REMARKS

Regarding the Office Action:

Regarding the Objection to the Drawings:

FIG. 10A
(PRIOR ART)

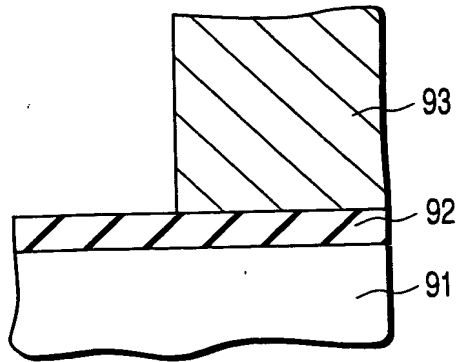
The Examiner objected to the drawings, stating that Figs. 10 – 12 and 15 – 17 should be designated by a legend, such as “prior art.” The Examiner also objected to Fig. 12B as failing to comply with 37 C.F.R. 1.84 (p)(4), “because reference character “105” has been used to designate both a *resist pattern* and a *width reduced pattern*” (Office Action, page 2, italics in original).

In response, Applicants file herewith four (4) sheets of drawings, each labeled “Replacement Sheet,” containing Figs. 10A, 10B, 11A, 11B, 12A – 12D, 15A – 15C, 16A – 16C, and 17. Applicants have amended Figs. 10A, 10B, 11A, 11B, 12A – 12D, 15A – 15C, 16A – 16C, and 17 to add the legend “Prior Art,” as required by the Examiner. In addition,

FIG. 12B
(PRIOR ART)

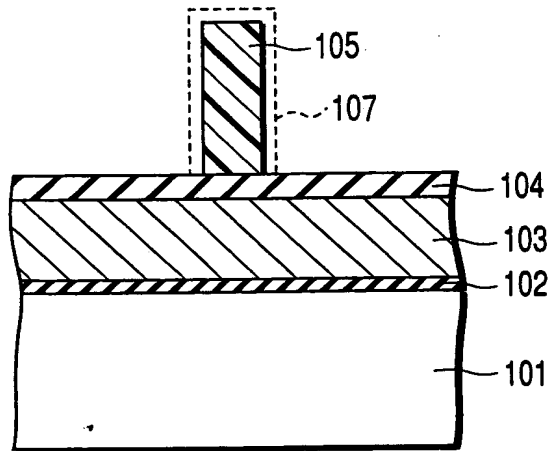
Applicants have amended Fig. 12B to replace item 105 with a new reference 107, as follows: “a resist pattern ~~[[105]]~~ 107 (a portion indicated with a dashed line) is formed.” Applicants submit that this overcomes the Examiner’s objection to Fig. 12B and thereby satisfies the requirement for a proposed drawing correction.
